ADDENDUM #2

ITB NUMBER: 2014038-PW-B

South Main Street Traffic Signal Upgrades ITB

DATE: March 11, 2014

SHEET
2

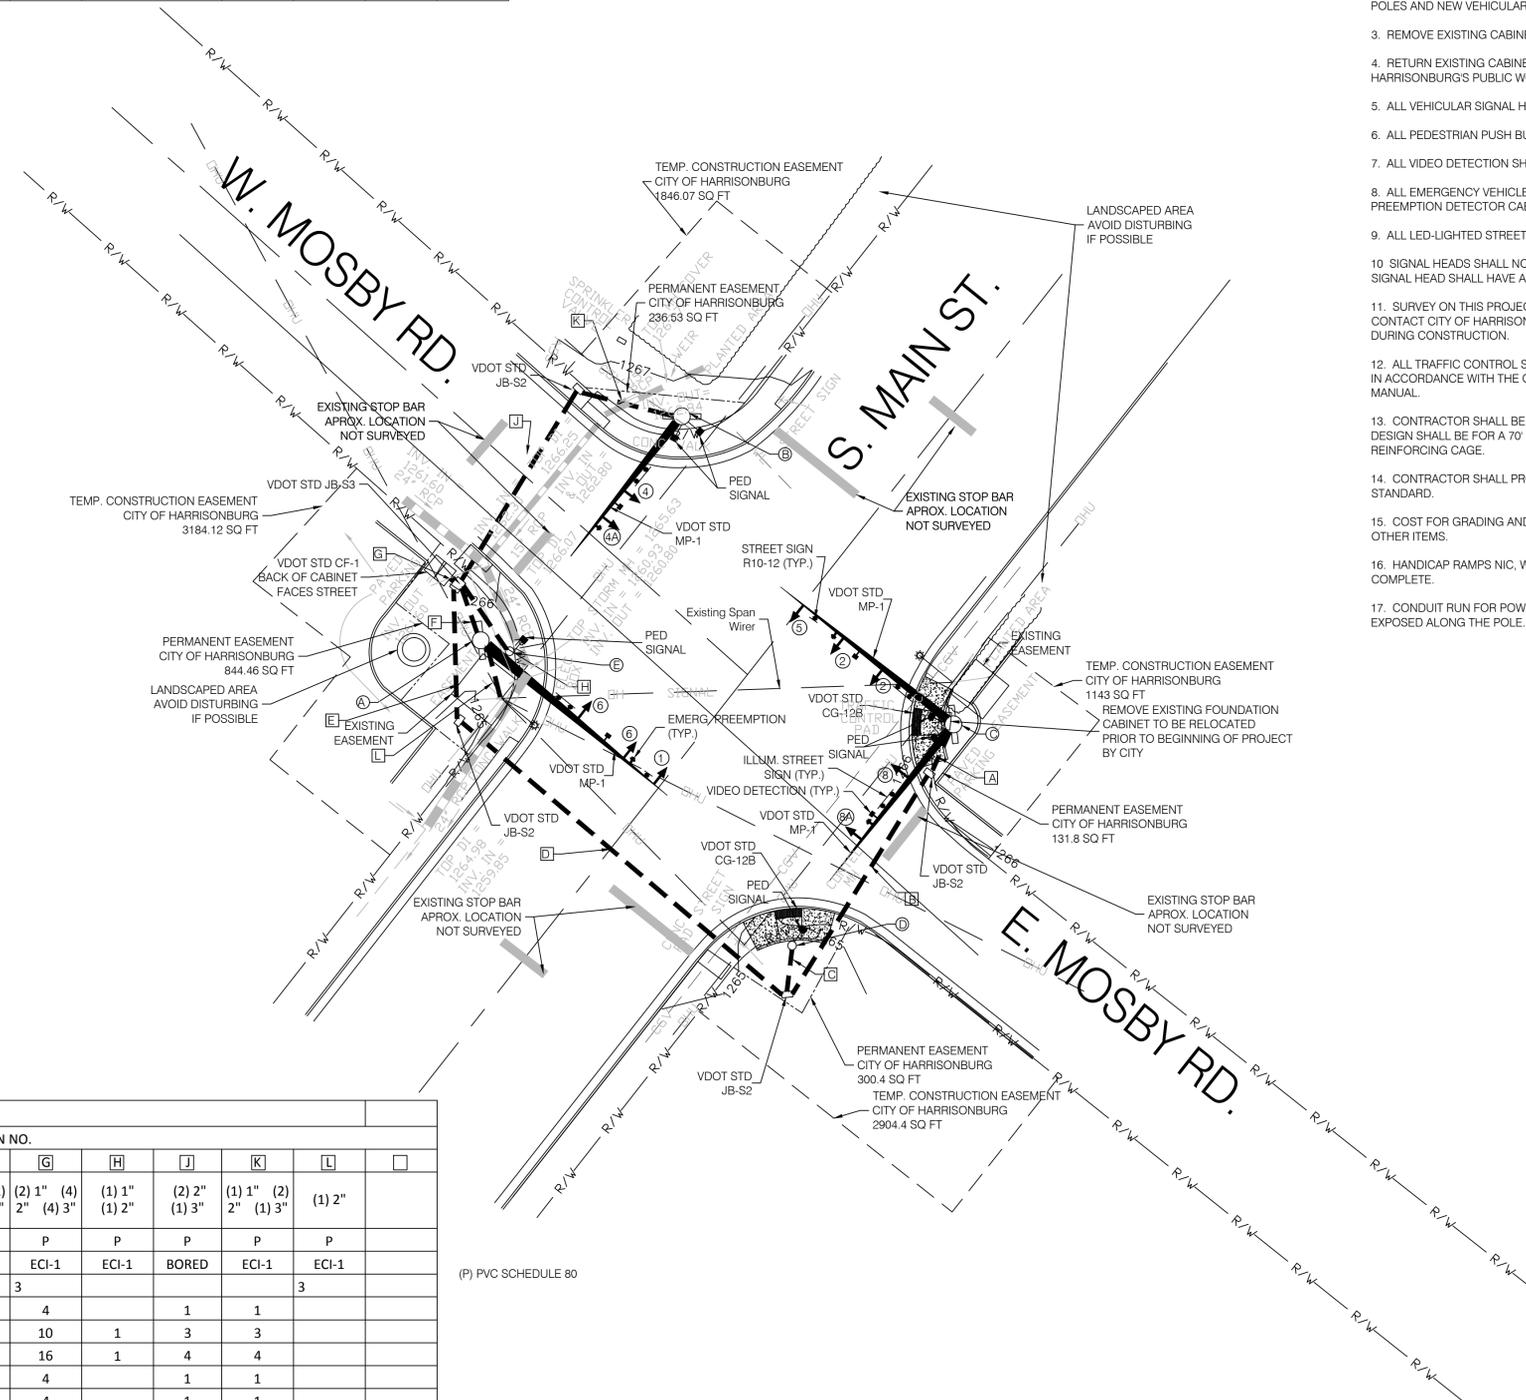
- h. Changed electrical service standard from SE-3 Type B to SE-5 in the notes.
13. The following revisions apply to the South Main Street & Mosby Road plan sheet (Sheet 2, attached below):

- a. Signal head labels were changed to match intended phase numbers.
 - b. For the mast arm attached to signal pole 'C' for the eastbound approach of West Mosby Road, the signal head for the left lane has been revised to show a 4-section head.

- c. On the same pole, the signal head for the right lane has been revised to show a 3-section head.
 - d. The signs labeled as "R-12 (TYP)" on the South Main Street northbound and southbound mast arms should be "R10-12 (TYP)" (Left turn yield on Green).

- e. Gas line (labeled as "CGV") was corrected to extend through the intersection instead of just being shown on the corners.
 - f. Changed electrical service standard from SE-3 Type B to SE-5 in the notes.
